## Memorandum

Date: December 7, 2022

Re: Additional hydrologic analysis in response to Dr. Rhett Jackson's 11/22/2022 comment

Figure 1. Flow exceedance at USGS 02231000

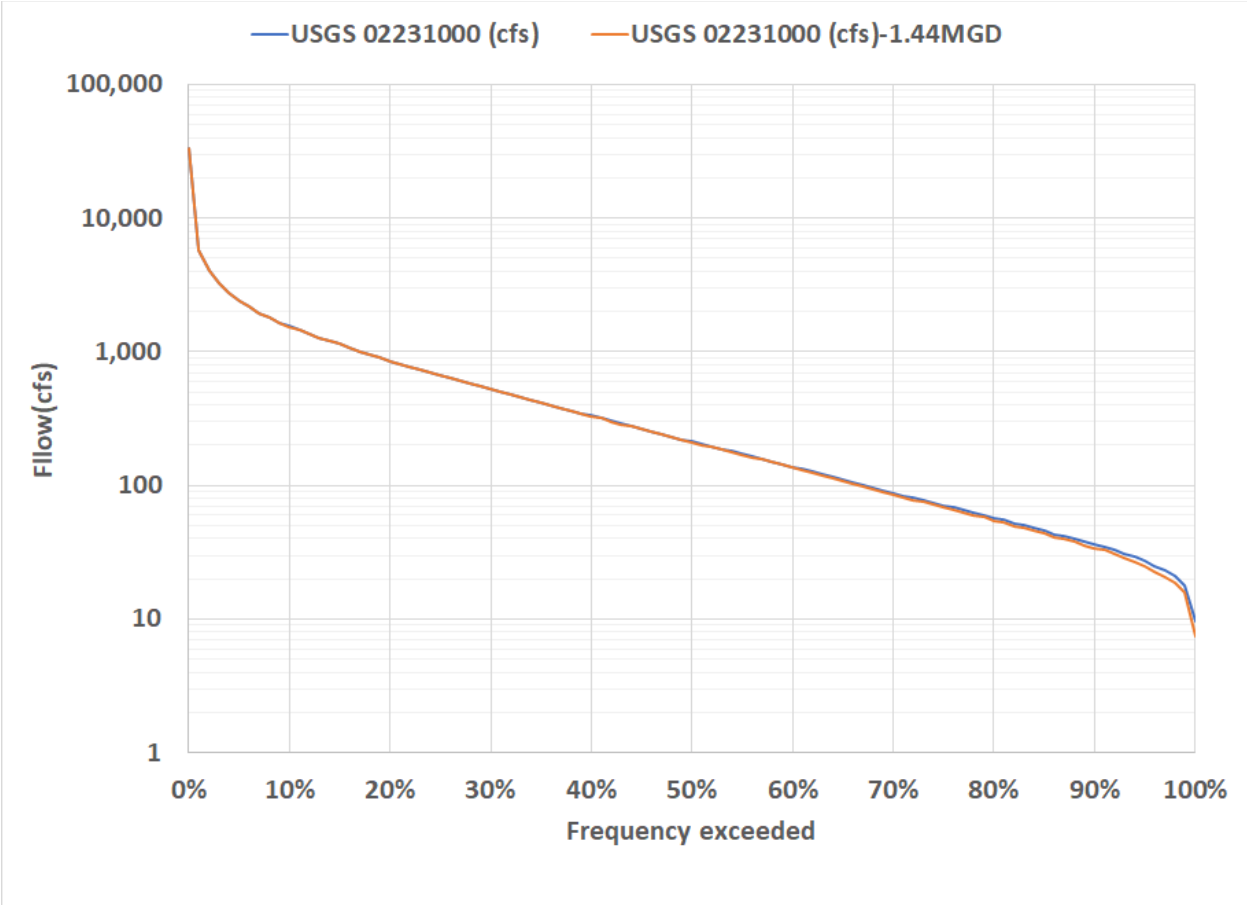
In Dr. Rhett Jackson's November 22, 2022 comment letter, he used USGS gage 02228500 (North Prong St. Marys River at Moniac, GA) in assessing the potential impact from the mining pit seepage and associated dewatering. This gage controls 160 square miles of drainage area, has 28,351 days of daily record, and has a more or less continuous record since the early 1950's (with a gap of about two years from October 2004 to October 2006). Dr. Jackson concludes that the occurrence of extreme events at the very low end of the flow spectrum would be tripled had the St. Marys River been impacted by TP's dewatering of the mine pit.

In order to make our point and maintain conservative, we continue to use the 1.44 mgd (2.23 cfs) as if it is entirely removed from the St. Marys River. Flow exceedance curves have been developed for the original gage record and an altered flow sequence as if 2.23 cfs has been removed from the original flow sequence. The two curves are very close for the upper 80% of the flow spectrum (Figure 1). We developed Figure 2 to zoom in to the lowest 30% of the flow exceedance. Here, we see the separation of the two curves, but the difference remains small. At the very low end of the flow exceedance curves, there may be an increase in the occurrence of such low flows (e.g. around 10 cfs). However, that is true when analyzing any magnitude of a flow reduction and on any stream.
